**Government of India
Bhabha Atomic Research Centre, Mysuru
Proj. SMF Challakere, Chitradurga**

Name of the Tender: Composite work of SITC of Electrical Systems and Design & Construction of civil works in Substations at SMFC, BARC, Challakere, Karnataka for:

Tender No.: BARC/SMFC/FMF/2024/LTSS/NIT; dt.: 23-12-2025

Corrigendum-1

Substation - 2 SLD

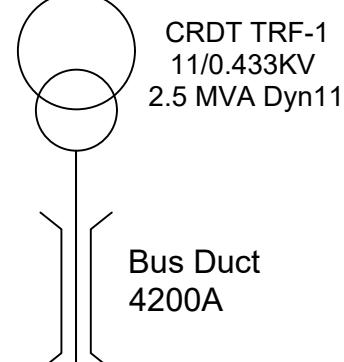
Note - BOQ S.NO - 4.04, Class-IV Panel Type-4 is not Indicated in SLD, Location and Incomers is to be Finalised as per Process load requirement during the Execution Stage.

BOQ S.NO - 4.01 Class-IV Panel Type-1

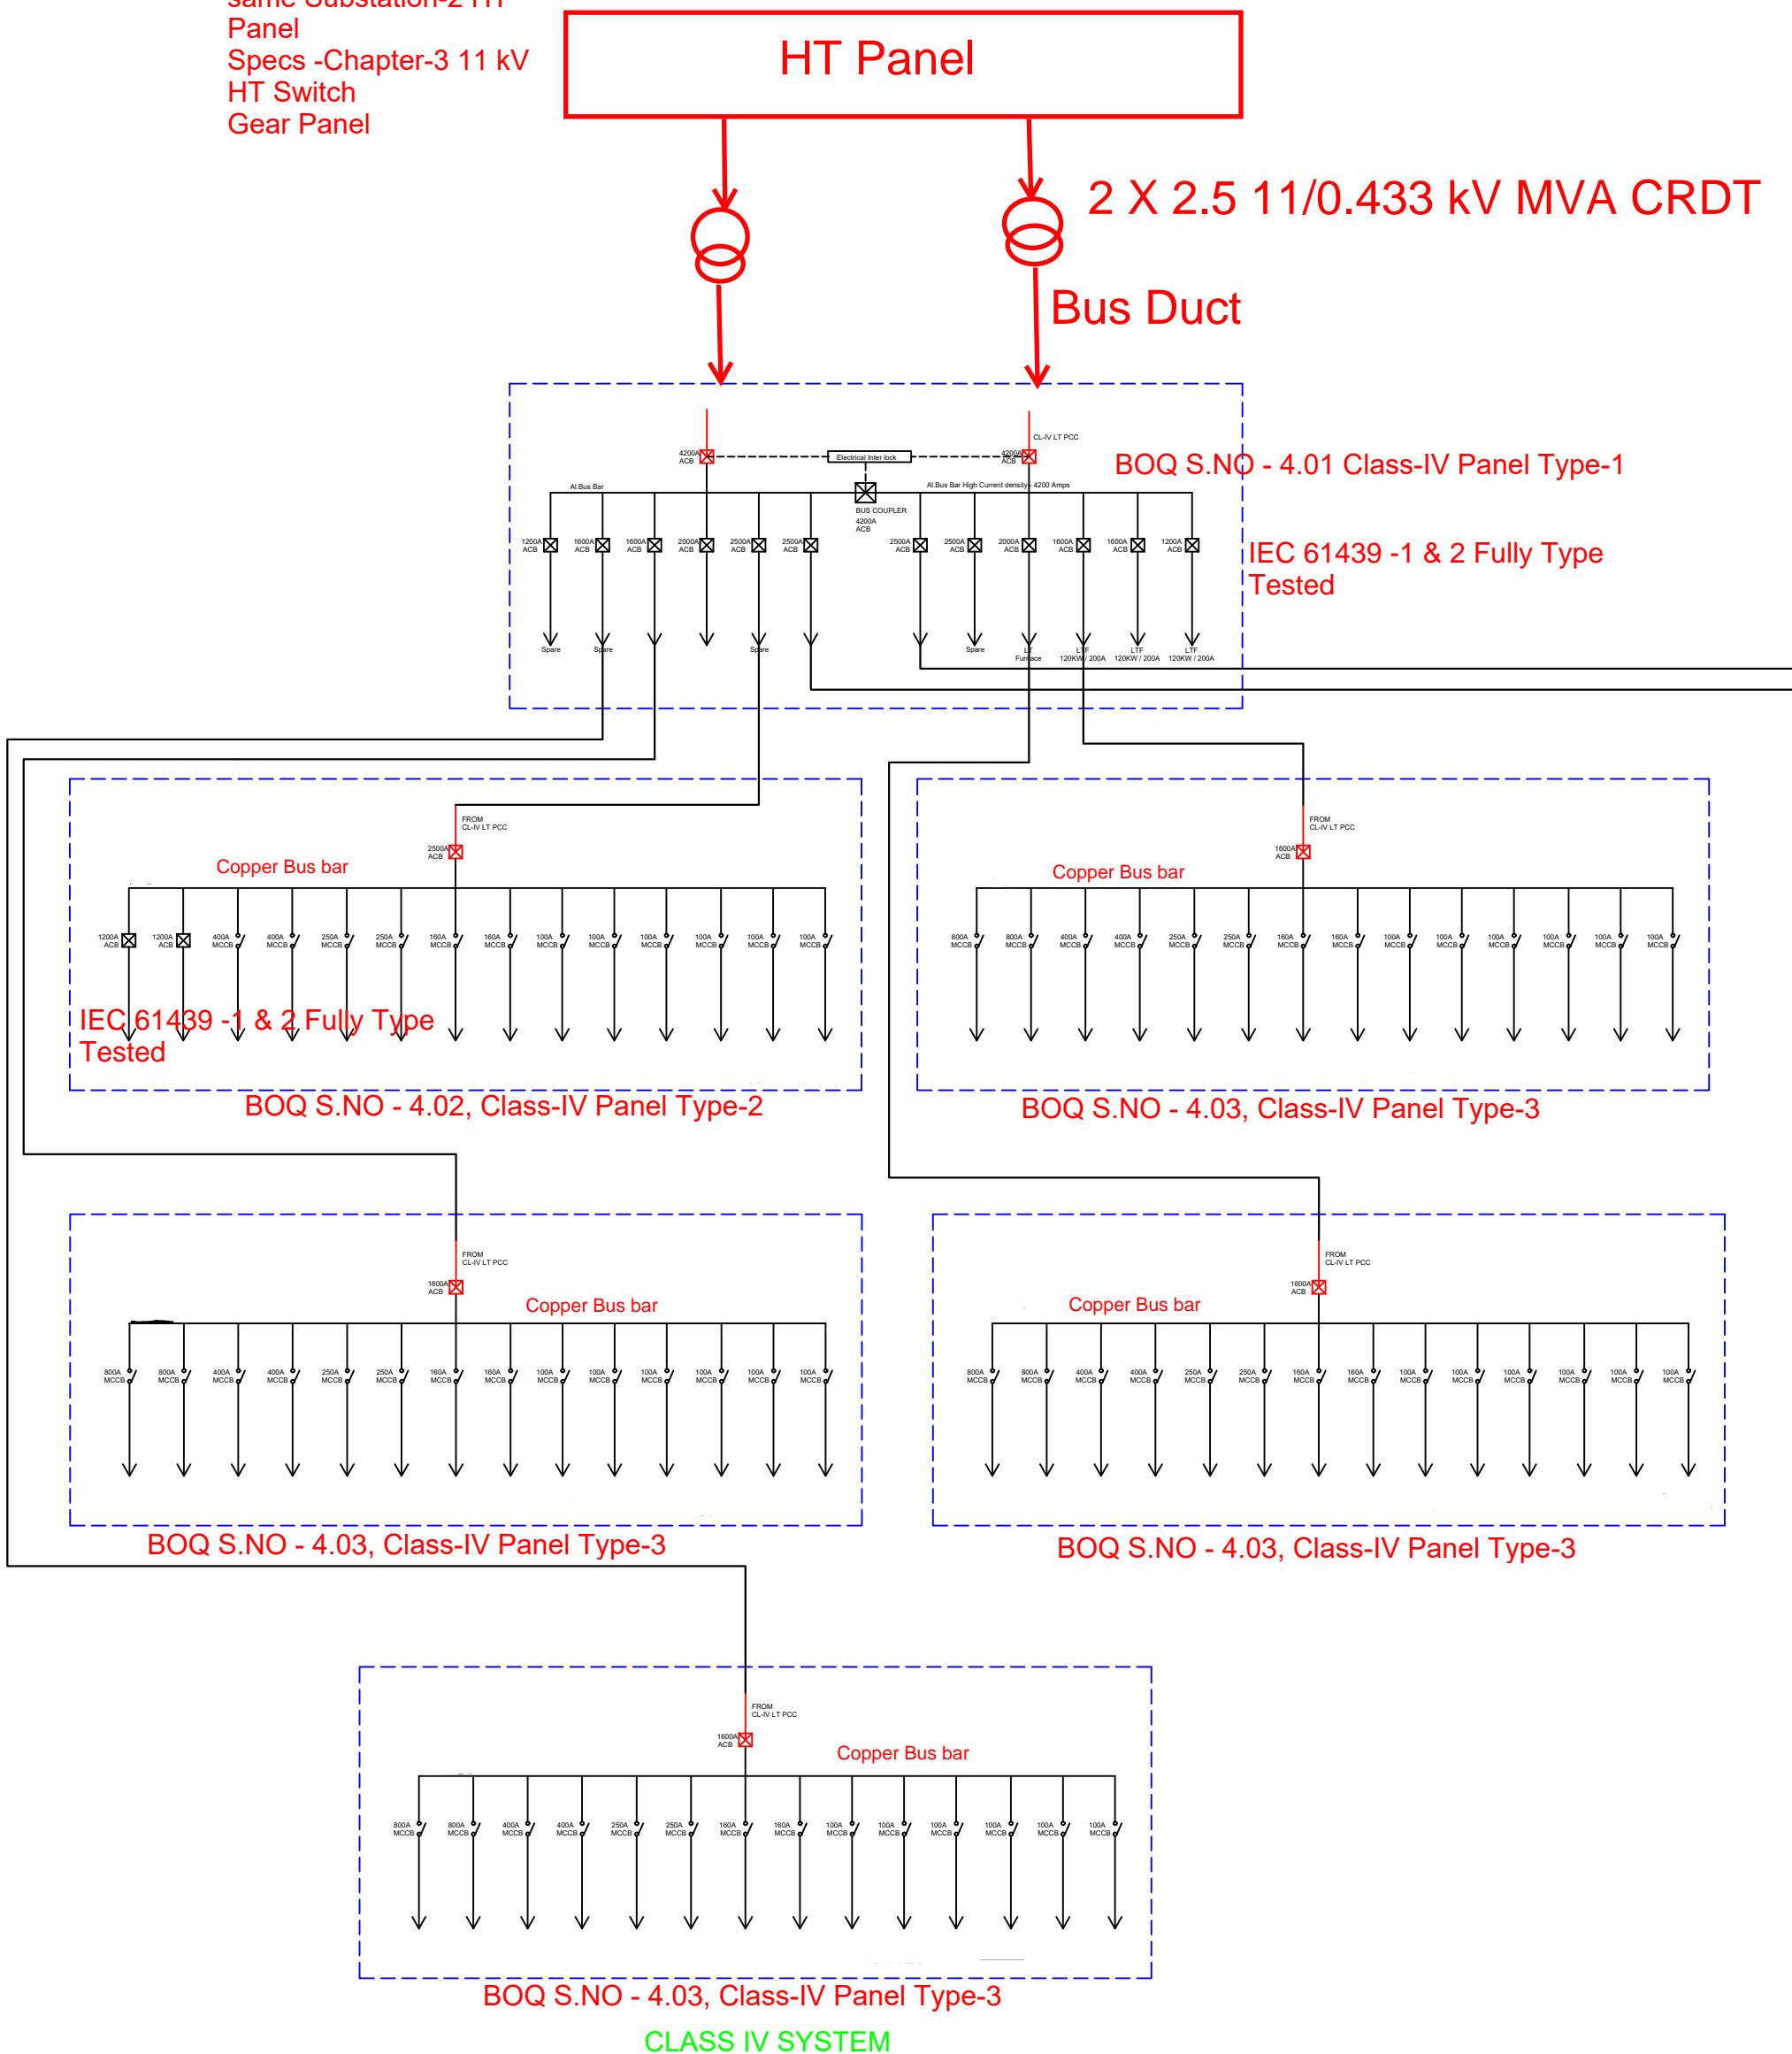
IEC 61439 -1 & 2 Fully Type
Tested
